BUILDABILITY EXHIBIT

Environmental Resource Inventory

LOT 1 BLOCK A SRIVATHANAKUL SUBDIVISION PROJECT ASSESSMENT

101 LAGO VERDE DRIVE
C8J-2021-0206.0APA

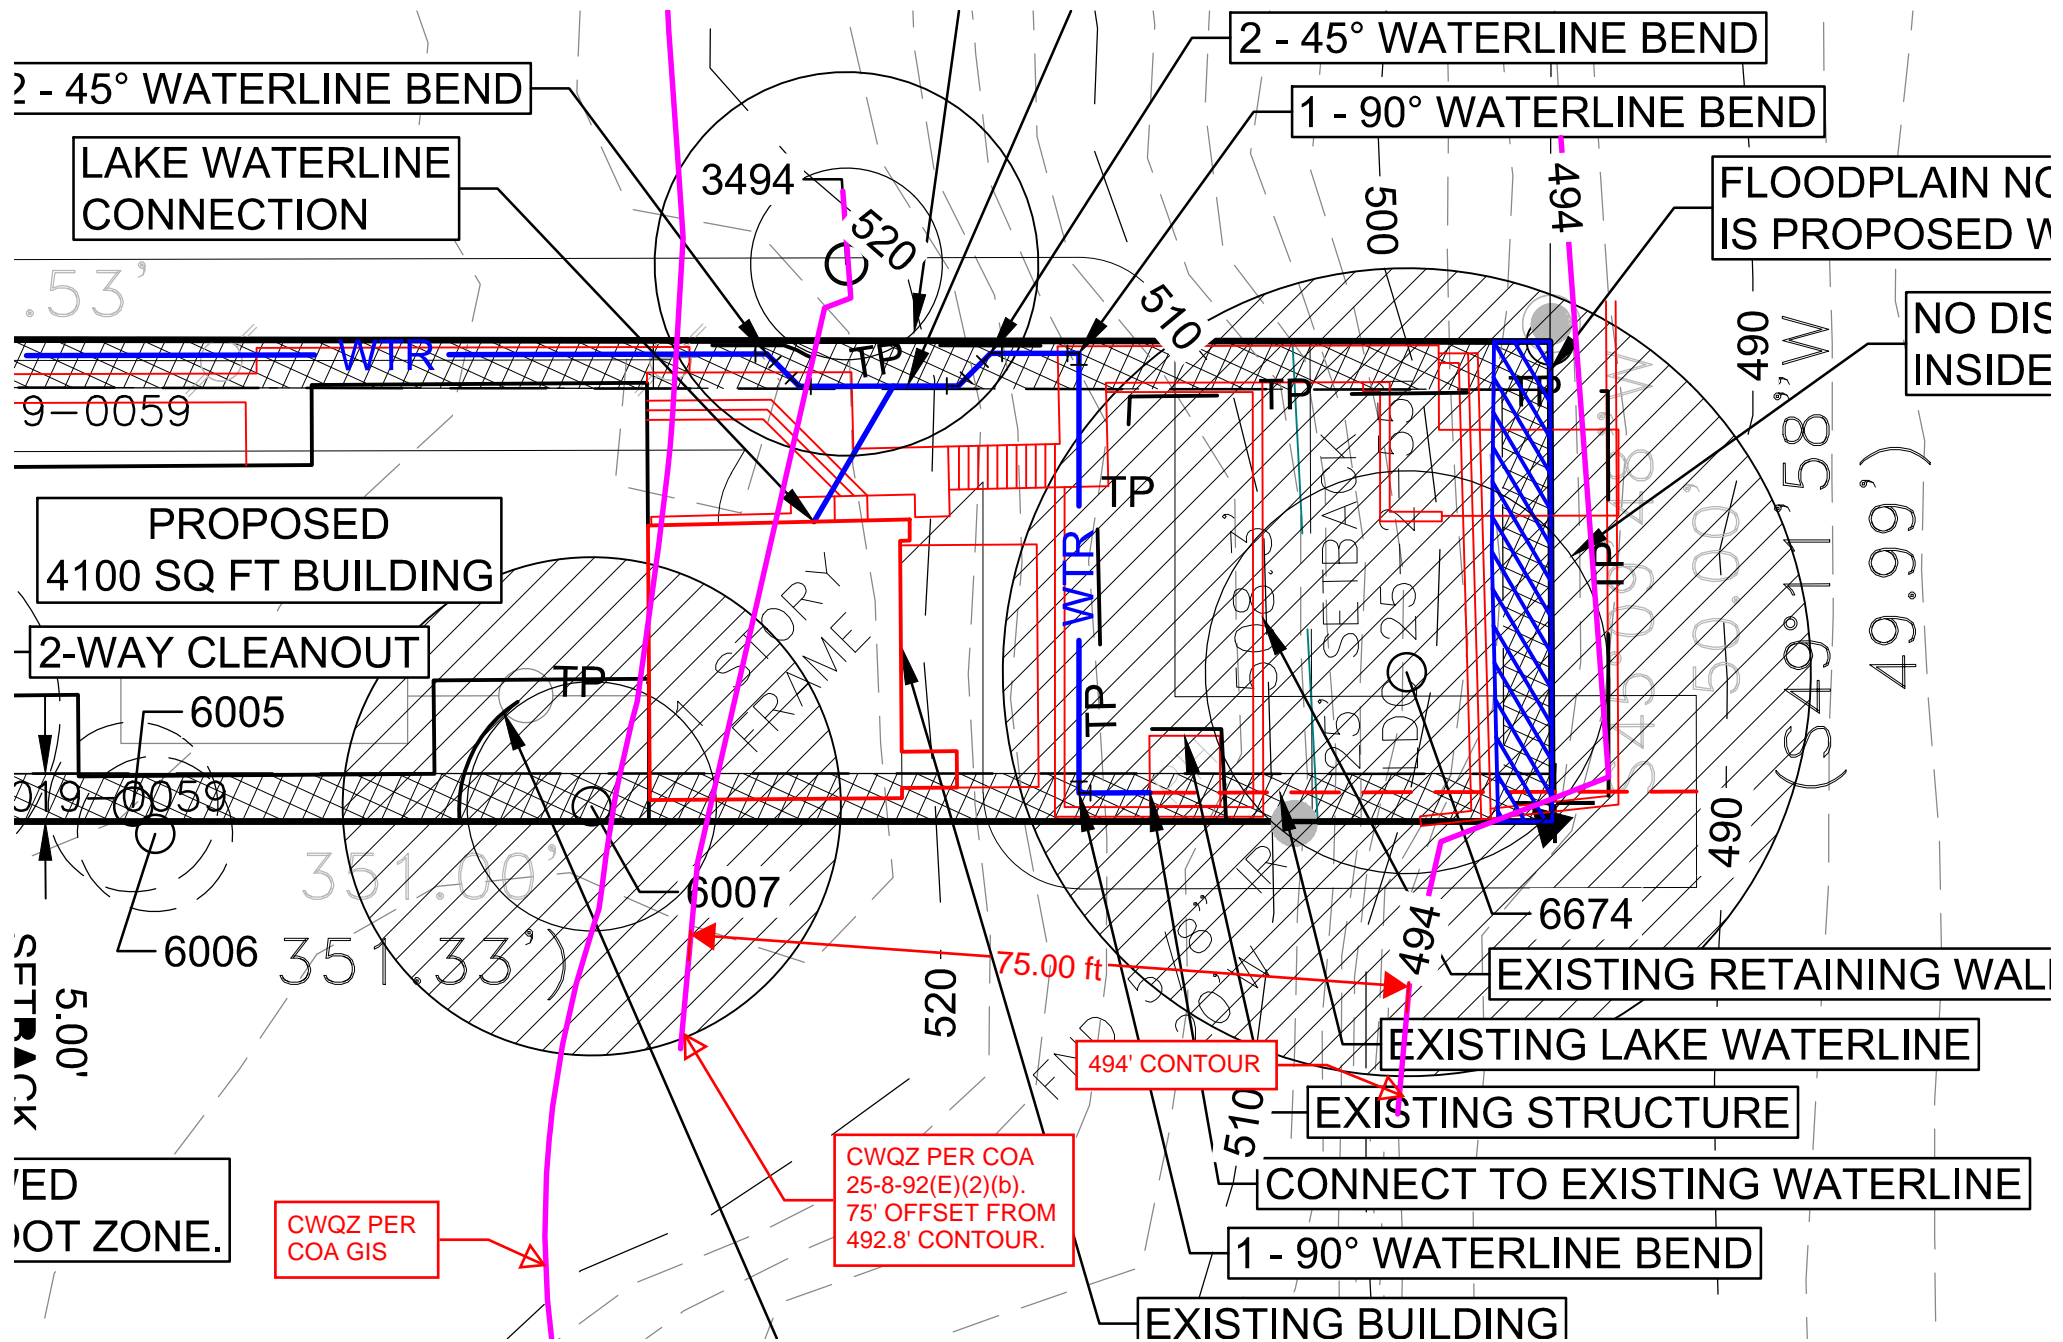
4. The proposed new construction will be in accordance with the buildability exhibit provided by the applicant to minimize disturbance to the Critical Water Quality Zone associated with Lake Austin. Specifically, the proposed addition to the existing house will be located to the northwest of the existing house to minimize disturbance to the Critical Water Quality Zone.

BUILDABILITY EXHIBIT

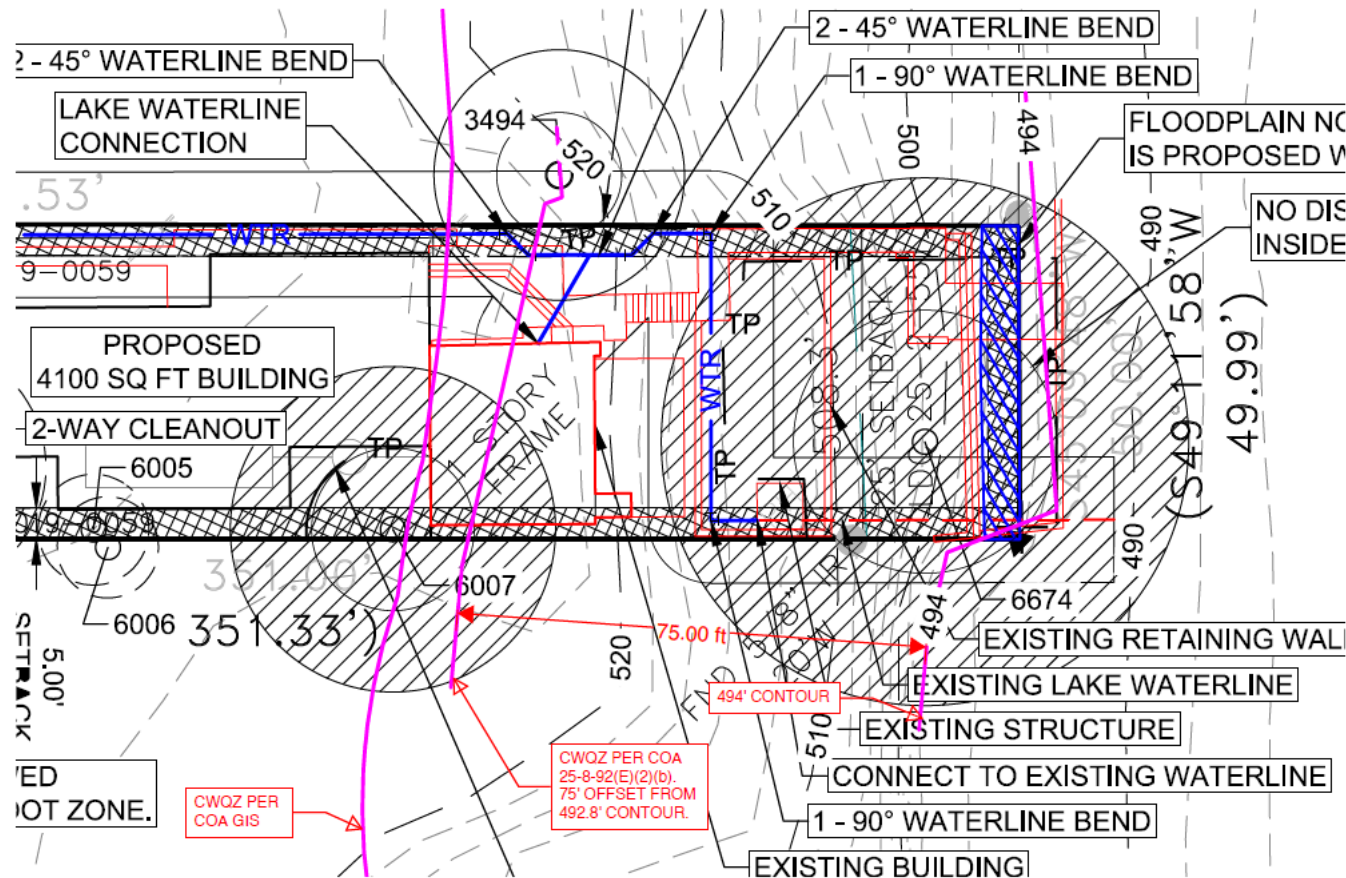
The proposed addition will be located to the northwest of the existing structure to minimize disturbance to the Critical Water Quality Zone.
